TECHNICAL NOTE				VELOCITY4	
Client	Kitewood Estates Ltd.			Page No.	1 of 19
Project	Site A Willow Way, Sydenham			Project No.	22/089
Subject	Technical Note in Support of Planning Appeal			Document No	TN004
Prepared By	PM/AM	Checked and Authorised By	MK	Date	11 May 2023

**Table 1-1: LBL Officer Report Comments on the Application and VTP Response**

**Table 1-2: LBL Transport Comments on the Application and VTP Response**

FOOTWAY WIDTH MEASUREMENTS

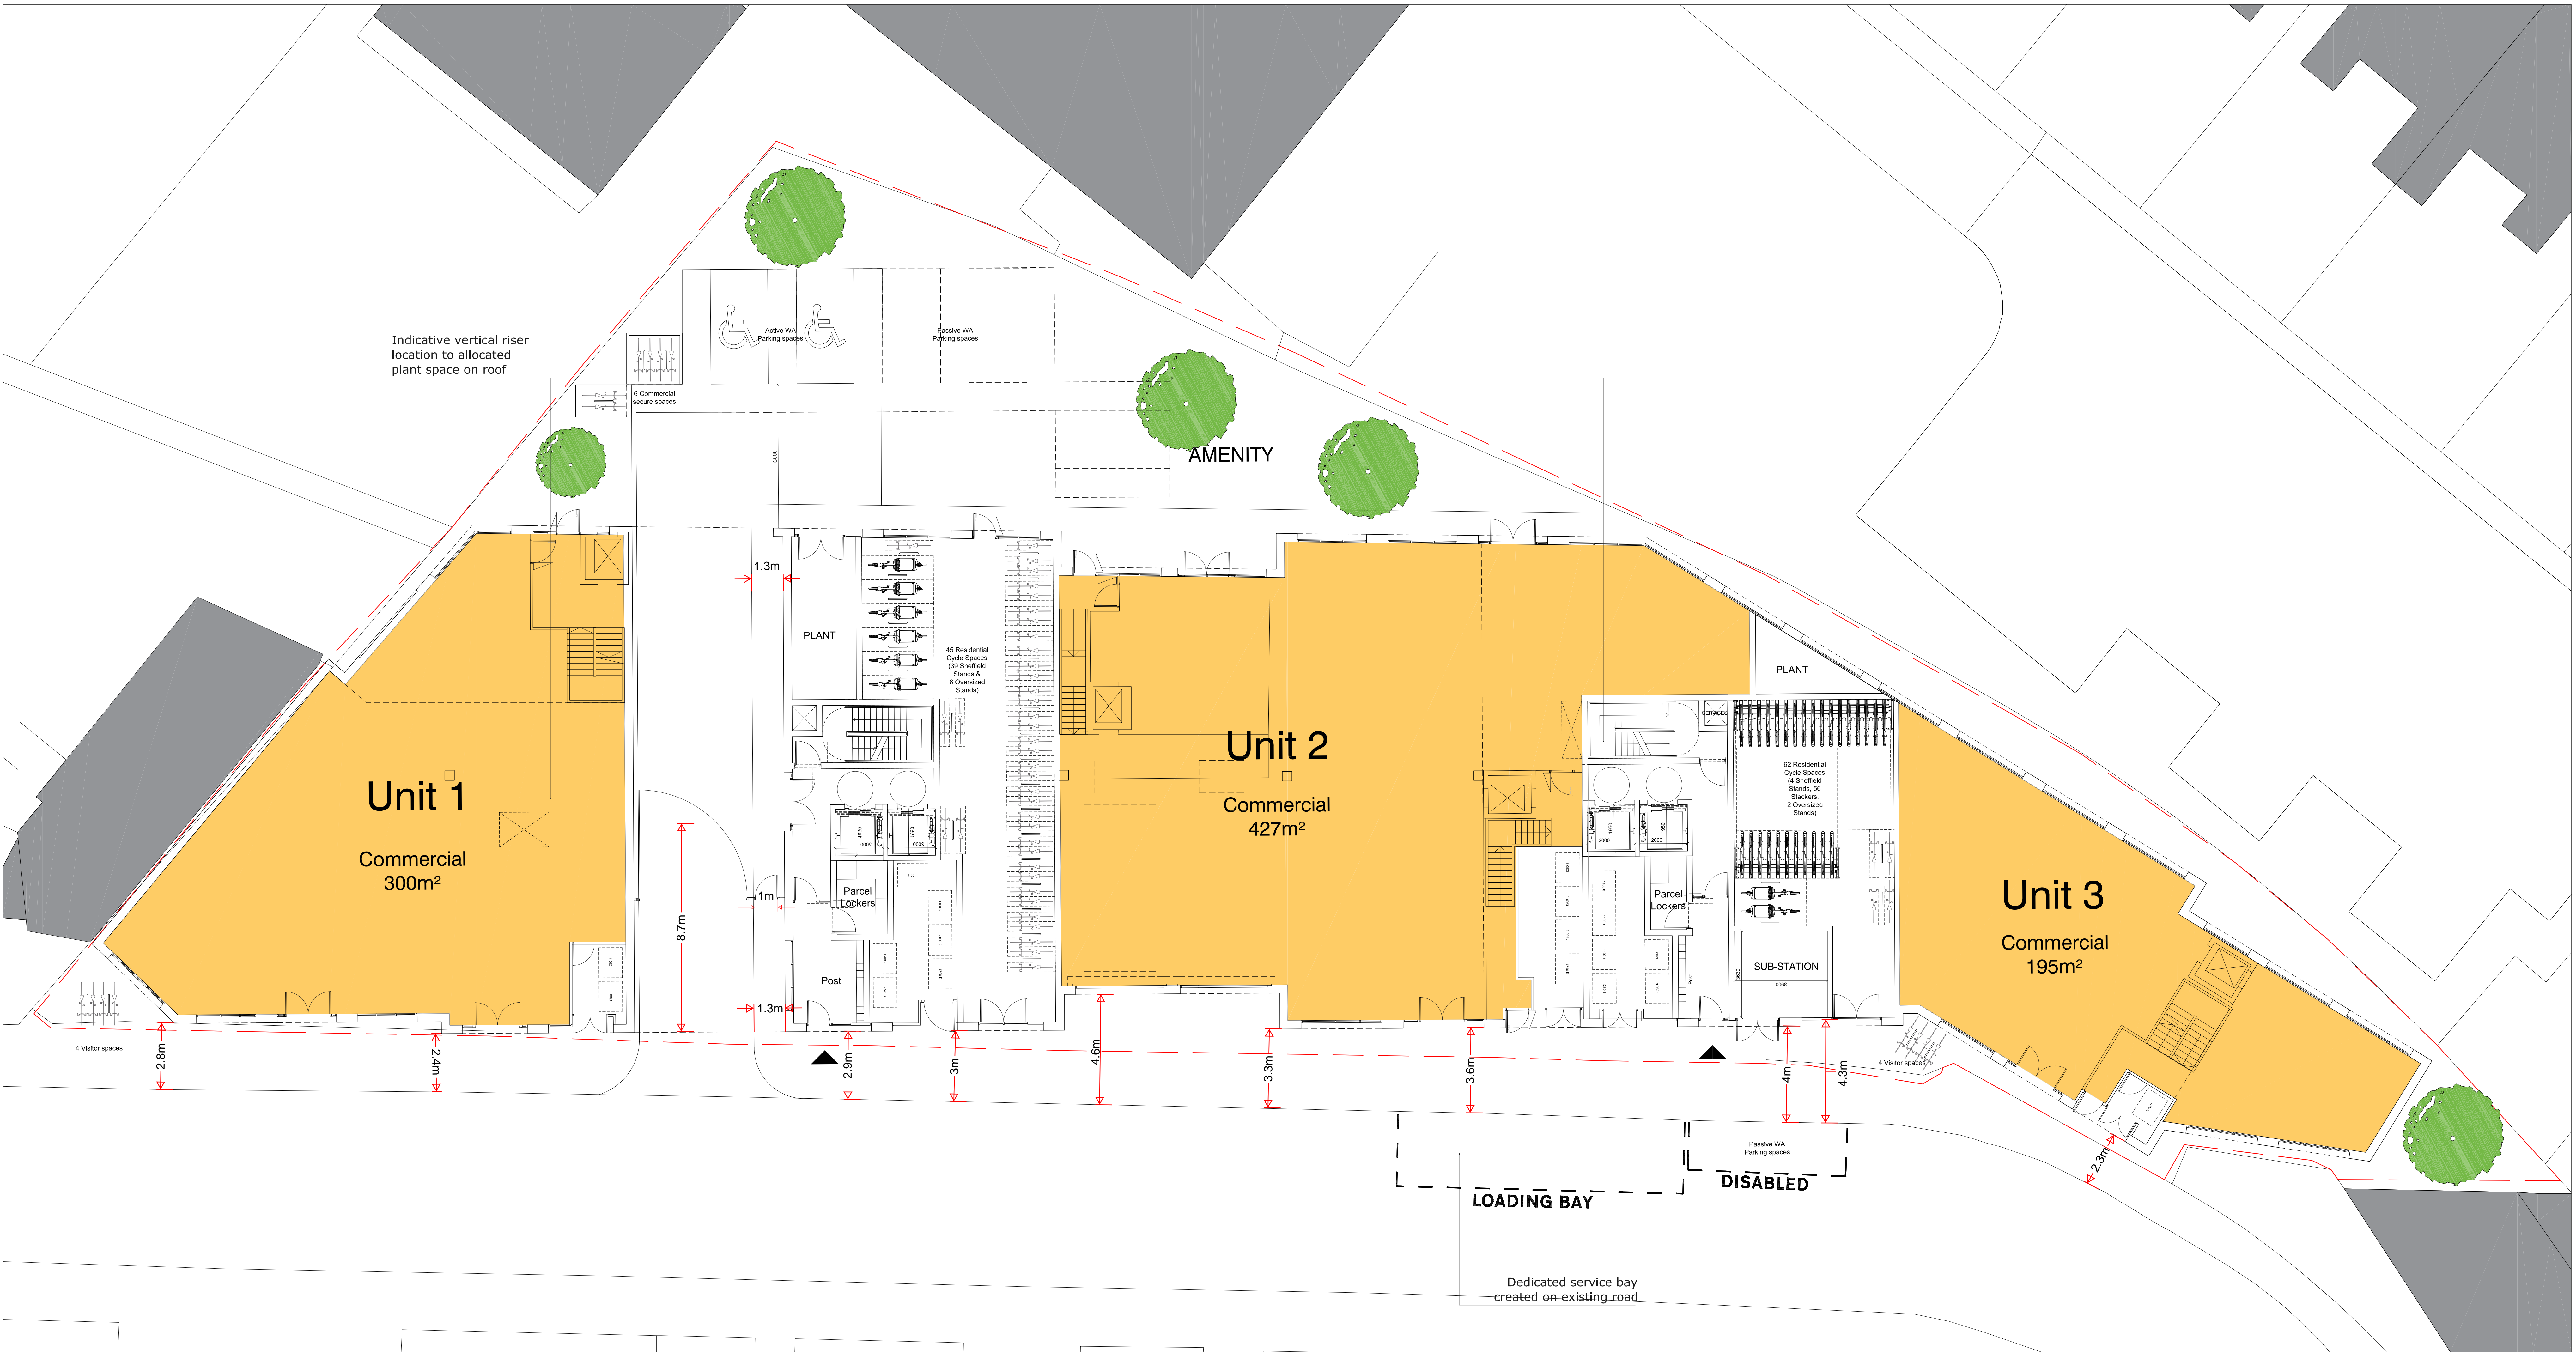
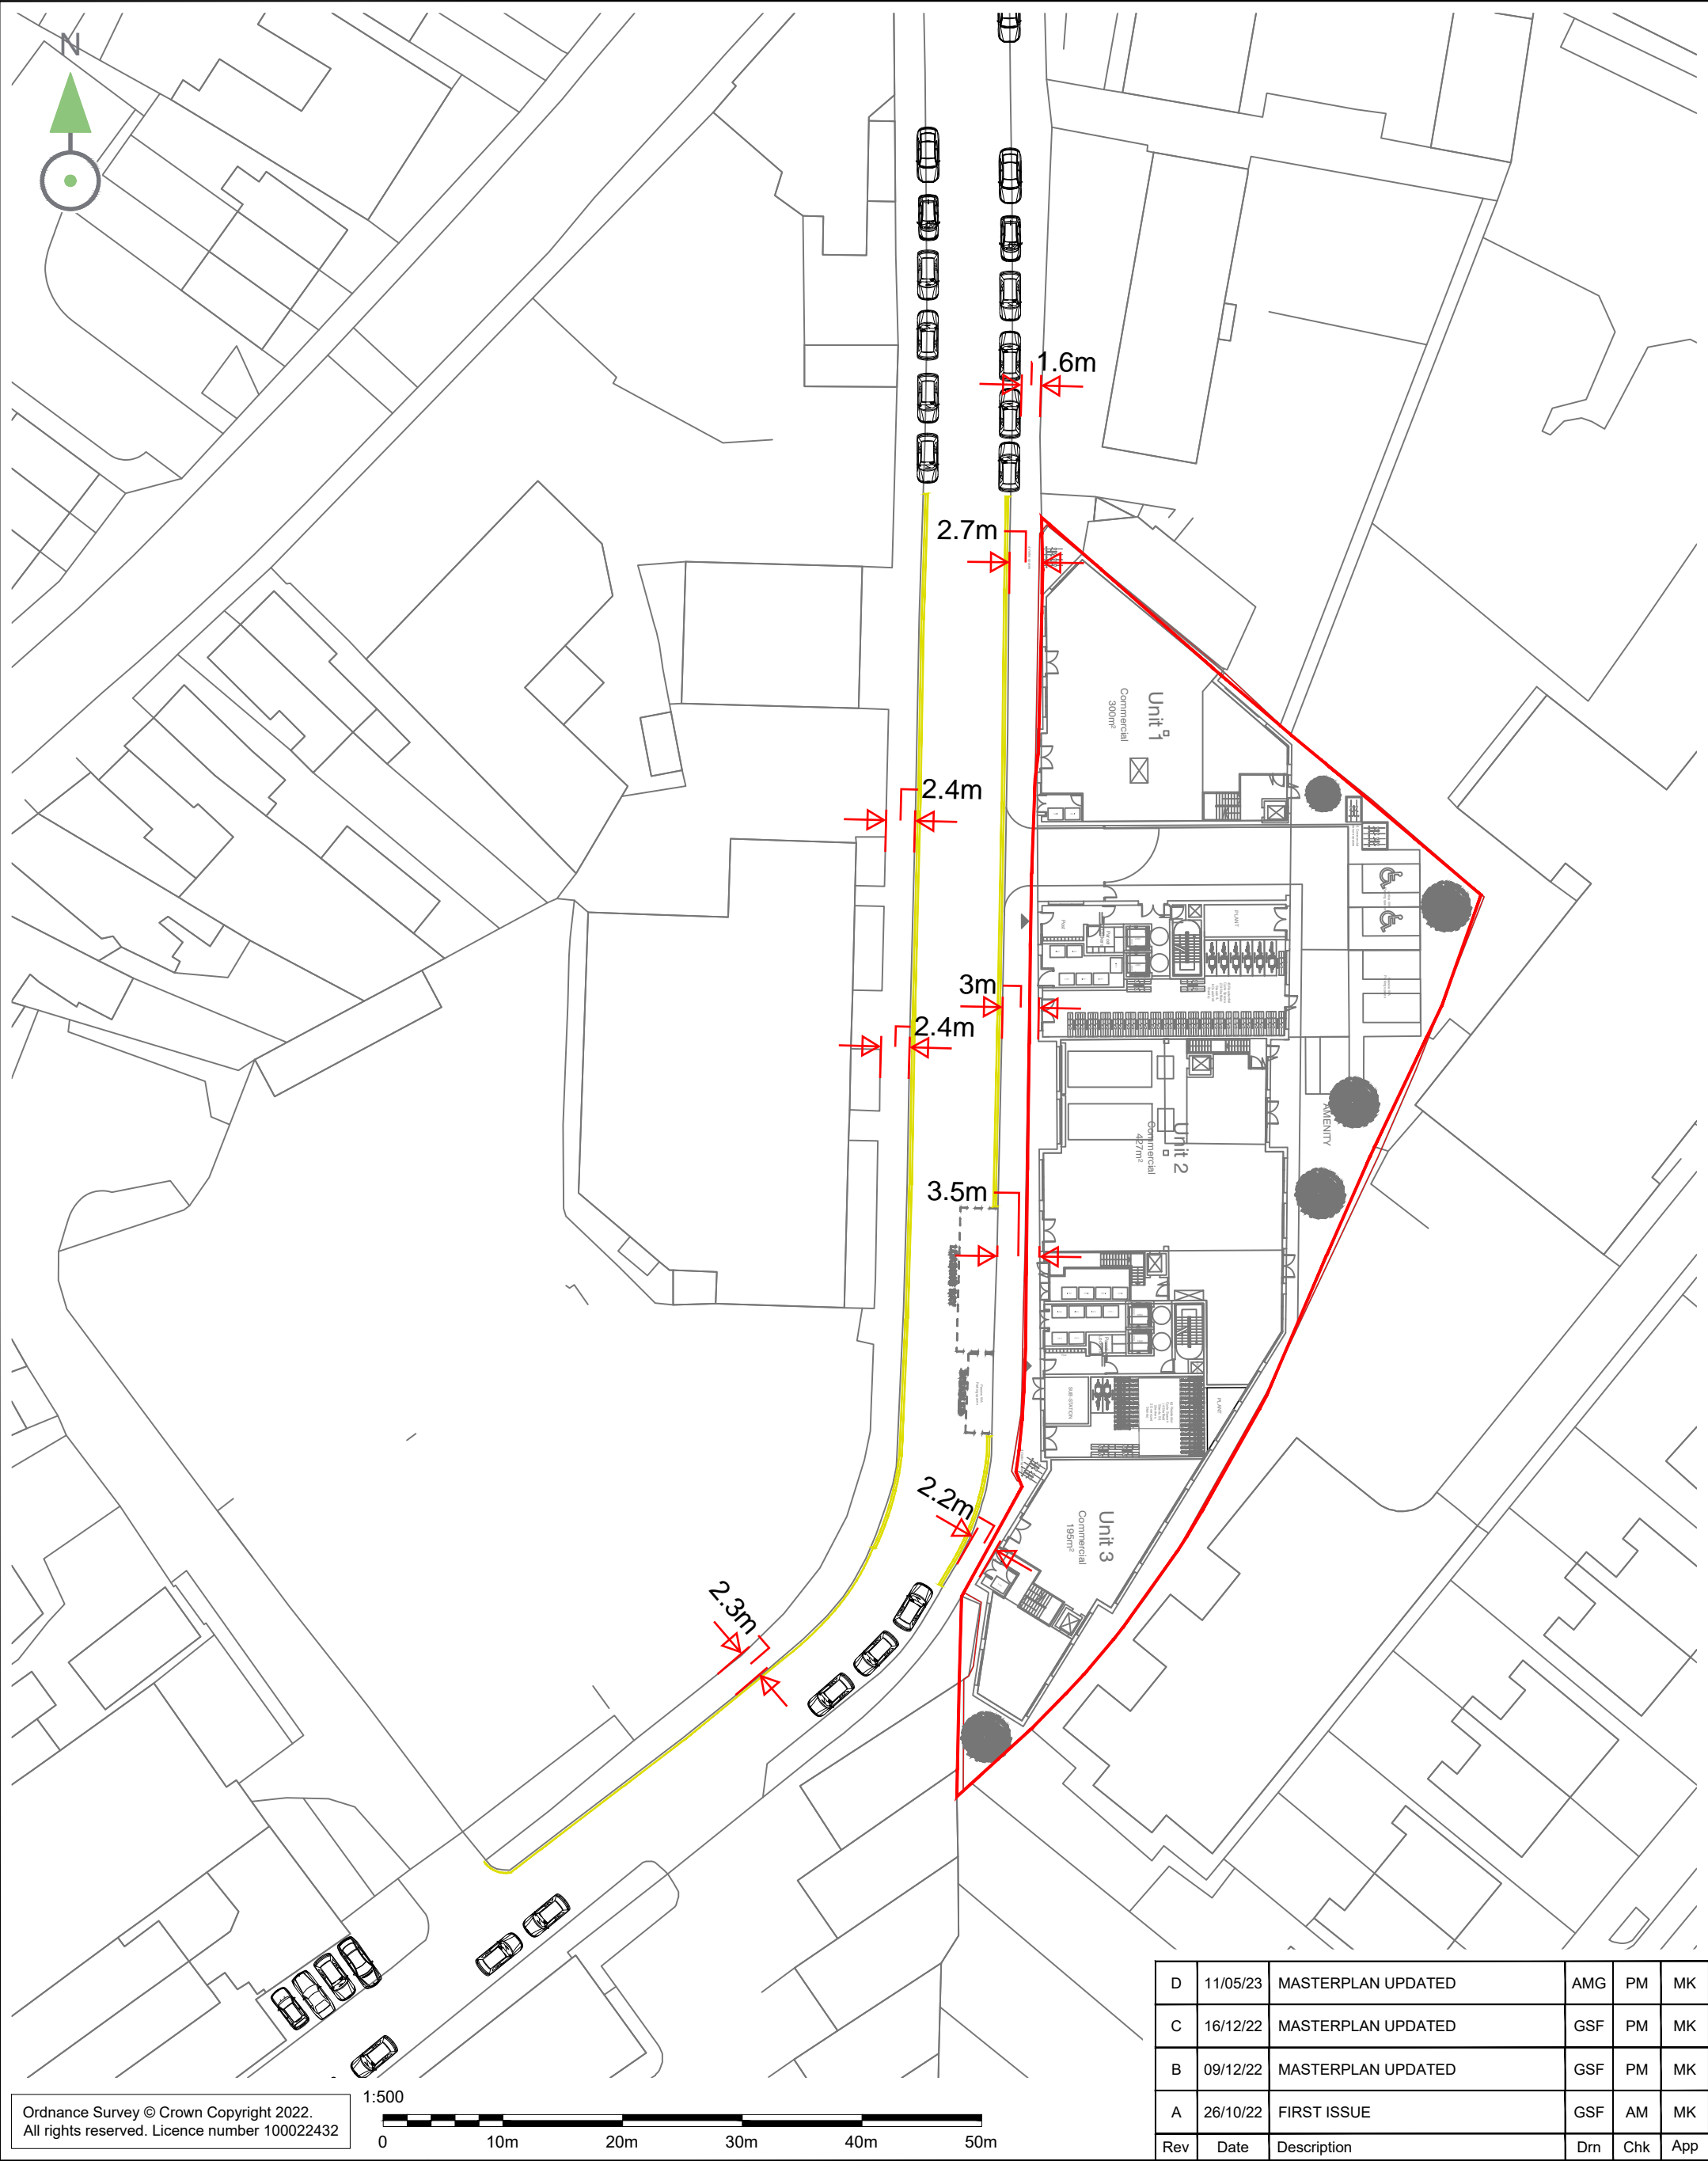
288	<p><b>Footway Widths:</b> Willow Way is subject to narrow footways on both sides of the carriageway. As part of this application the proposed ground floor plan shows a general footway width of 2.5 to 2.8m along the site frontage. However with the mounted kerbside parking this width would be reduced. The applicant will need to provide an assessment of how much effective footway width there will be for pedestrians with parked cars. The introduction of 60 residential units at a car free site indicates that there will be a high percentage of occupants travelling by foot, cycles and via public transport. The TA at paragraph 5.3.12 indicates that there will be a peak of 58 people trips in the AM period as a result of the proposed development. The existing footways along the front of the site would benefit from widening to accommodate the new development.</p> <p>It is noted that the LBL Highways consultation response also states that the "The width of the access is considered acceptable however the 1.2m footpath should be a minimum of 1.5m to allow for a pedestrian and a wheelchair user or pedestrian with a buggy to pass each other in accordance with TfL's Streetscape Guidance and in accordance with DfT's inclusive mobility guidance."</p>	<p><b>On-site Footway</b> The proposed footway alongside the vehicular access to the rear parking court measures 1.3m in width which is considered to be suitable due to the nature of the footpath (in a quiet, low traffic location), the footfall expected, and the length of footway required to be traversed for most journeys, which is 8.7m from the site boundary to the double door entrance leading to the access core for the Unit 2 residential floors as shown below:</p>

PARAGRAPH	PLANNING OFFICER / LBL HIGHWAYS COMMENT	VTP RESPONSE
		<p>This footway could be provided flush to the carriageway (with a footway delineated using paint or blockwork) to significantly increase the effective width. Aside from this, TfL's Streetscape Guidance notes that footway clear zones such as the footpath in question have an acceptable minimum of 1.5m, or an absolute minimum of 1.0m (page 210). It is noted that the guidance also states that the maximum length of the restricted width footway should be 6.0m which is slightly exceeded in this instance. Given that this is a section of footway largely falling within a private development, which will be subject to low pedestrian flows, this is considered to be an acceptable arrangement.</p> <p>Importantly, page 210 also states that <i>"the width of the clear zone provided should relate directly to the character and use of the street, and in particular the volume of pedestrians. The footway clear zone should be designed to comfortably accommodate peak pedestrian demand and satisfy acceptable levels of service"</i>. As this footpath serves one unit only, which includes an entrance from the Willow Way frontage, the volume of pedestrians using the footpath is likely to be very low (circa 20-30 movements in the AM peak hour) and congestion is unlikely to occur.</p> <p>Figure 6.8 of Manual for Streets (page 68) also suggests a footway width of 1.2m is sufficient for an adult and child to walk two abreast, and 1.5m would allow two adults to walk together, as well as an adult and pram/wheelchair user. Given the nature of this footpath which is a route between a building entrance and the public highway, it is unlikely that pedestrians will be materially impacted by not being able to walk two abreast, and it is unlikely that a vehicle will use the access at the same time as they access/egress the site given the low number of disabled parking bays provided on-site.</p> <p>Pedestrians are therefore considered unlikely to be adversely impacted by this footway being 0.2m narrower than what is considered by LBL to be the acceptable minimum. See <b>APPENDIX A</b></p> <p><b><u>Willow Way Footway</u></b></p> <p>With regards to the Planning Officer's comment regarding the footway width along the site frontage on Willow Way, it is important to note that the application includes a proposal to provide double yellow lines on both sides of the carriageway. This will prohibit parking on-street and parking half-on the footway (as is currently observed by drivers). This will prevent the effective width of the footway from being reduced by</p>

PARAGRAPH	PLANNING OFFICER / LBL HIGHWAYS COMMENT	VTP RESPONSE
		<p>kerbside vehicles, increasing it from around 1.5/1.6m of available width to a minimum of 2.2m of achievable width as shown in the plans in <b>Appendix A</b>. The typical footpath width along the site frontage will be around 3m which is a significant improvement on the existing situation.</p> <p>1.5m is also considered to be the minimum acceptable width for a footway clear zone as stated in TfL's Streetscape guidance, allowing for a wheelchair user and person walking to pass one another. Therefore, in the rare event that a vehicle driver fails to observe the proposed double yellow line restrictions, the footway width would remain of a width that is considered to be acceptable.</p> <p>It is therefore considered that the proposal will improve the effective footway width along Willow Way by addressing the issue of vehicles mounting the kerb, with a minimum width of 2.2m and a maximum of 3.5m along the site frontage. The proposed width will also be sufficient for the peak hour pedestrian demand associated with the proposed development. See <b>APPENDIX A</b></p>
